October 2, 2013

**RE: Construction Storm Water Inspection at Dublin Alzheimers Special Care Center/ Franklin County, Permit Number: 4GC04225\*AG**

Figure 4 inlet protection requiring maintenance.

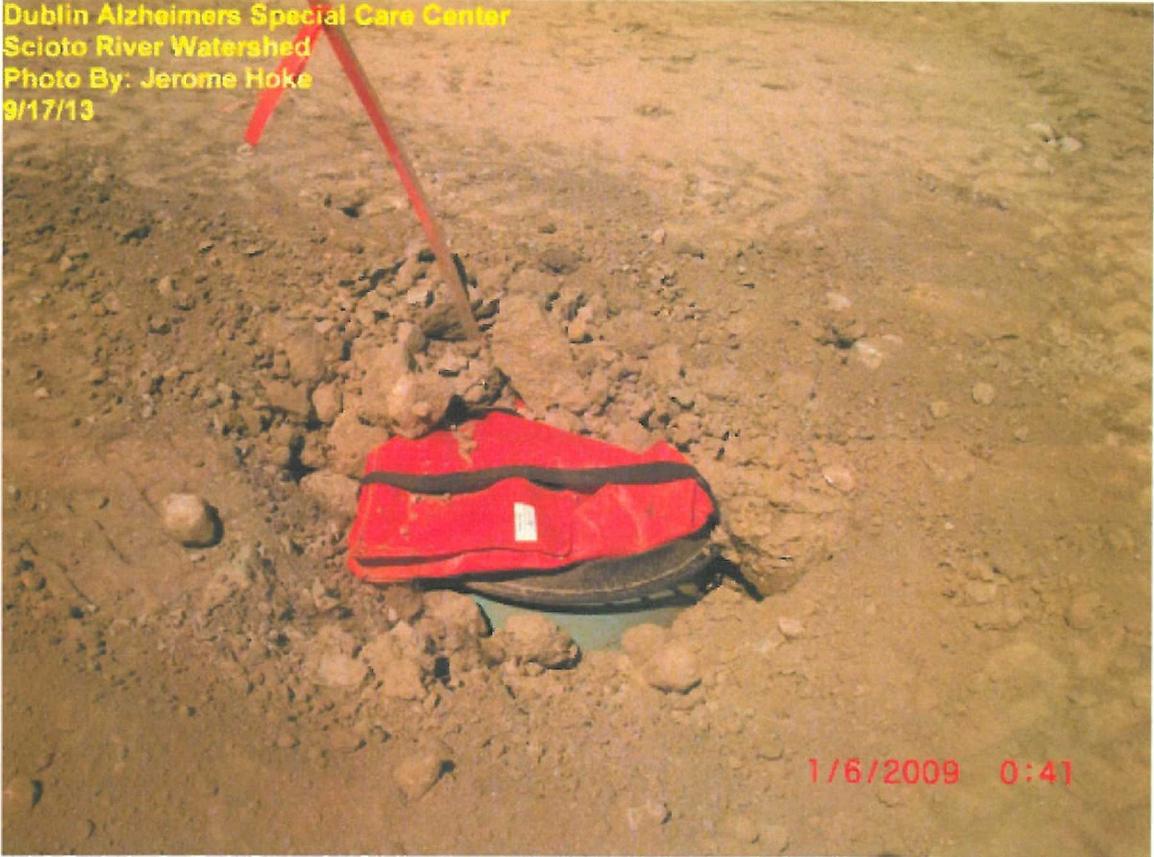
- The inlet protections noted on site have become worn and will require maintenance at this time (See Figure 4). In addition, please ensure that inlet protections that are below grade do not become overburdened with sediment (see Figure 5). If overburdening occurs please ensure maintenance to these inlets.
